Partial Revision of Work to be Performed for Enhanced Safety Measures (Overview)

<<Image of diverse placement>>

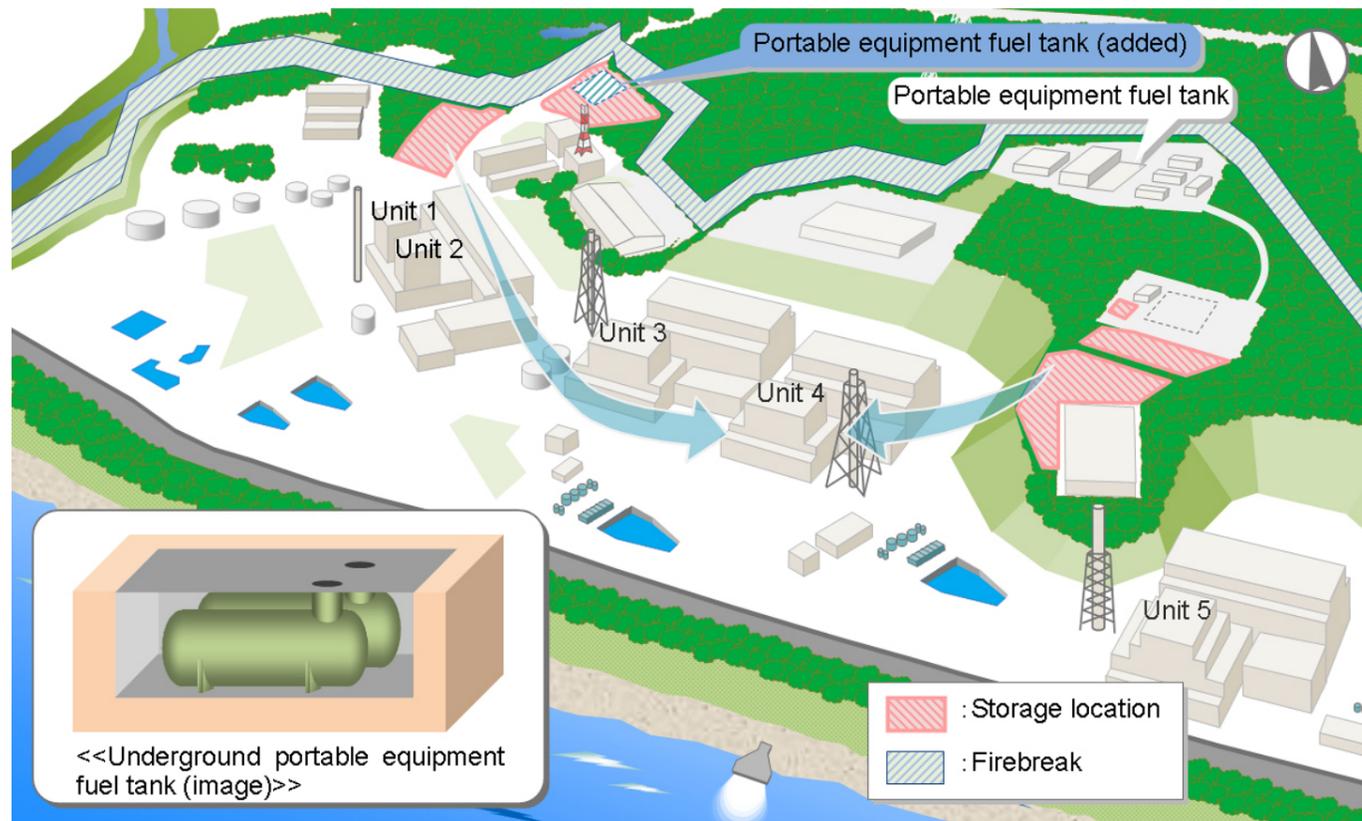
- In order to make the emergency response center reliably available during severe accidents, the placement of emergency power supply equipment and ventilating facilities at diverse locations was taken into account for an additional building to be newly constructed. By placing at diverse rooms partitioned by fire walls, Chubu Electric Power will strengthen fire resistance measures.
- For air conditioning function, the performance will be enhanced so as to improve the work environment for disaster response personnel after ensuring earthquake resistance.
- The building area will expand by reviewing the above.
- For this reason, the design of the emergency response center (the additional building) will be reviewed in the future, and building construction / the manufacturing and installation of equipment will be conducted.

<<Regarding the automatic fire extinguishing system>>

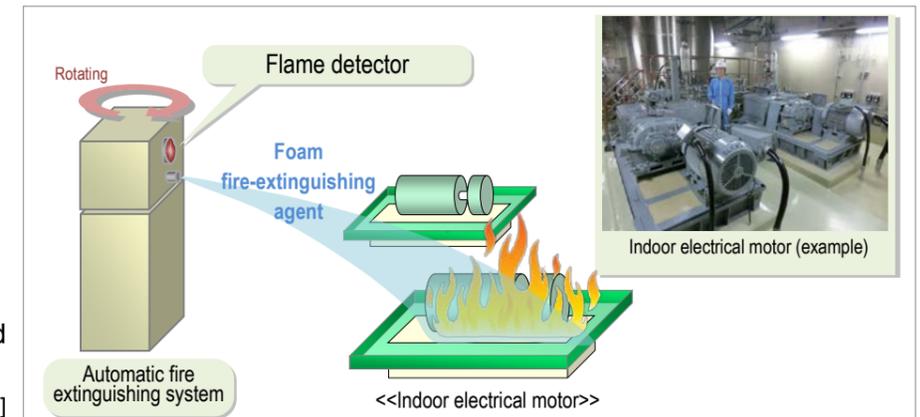
- Fire extinguishing systems depending on the type of fire will be introduced additionally to expand the correspondence range of fire extinguishing equipment that does not require the self-defense fire brigade to go to the site of the fire.
- For the fire on equipment containing oil inside such as electrical motors etc., an automatic fire extinguishing system which measures the distance to the flame and extinguishes the fire automatically or remotely and water cannon will be installed.
- For the fire occurred at power-supply equipment, in-panel fire extinguishing system will be installed to automatically extinguish fire inside of the power panels.

This will be installed near the indoor electrical motor. This system will monitor fires using a flame detector, and if a fire occurs, it measures the distance to the flame and extinguishes the fire automatically.

A foam fire-extinguishing agent with excellent cooling and suffocating performance will be used for fire fighting.

[Installation locations: Approx. 50 locations]

<<Regarding water cannons>>

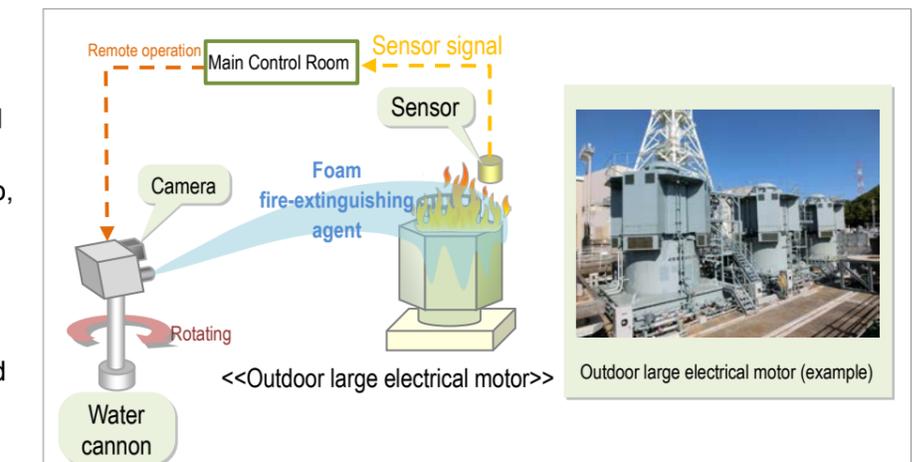
This will be installed near the outdoor large electrical motors, etc.

A signal is sent to the Main Control Room when the sensor is activated. While monitoring the camera's video, the Main Control Room will operate the water cannon remotely.

A foam fire-extinguishing agent with excellent cooling and suffocating performance will be used for fire fighting.

[Installation locations: Circulation Water Pump electrical motor, Primary Loop Recirculation pump electrical motor transformer]
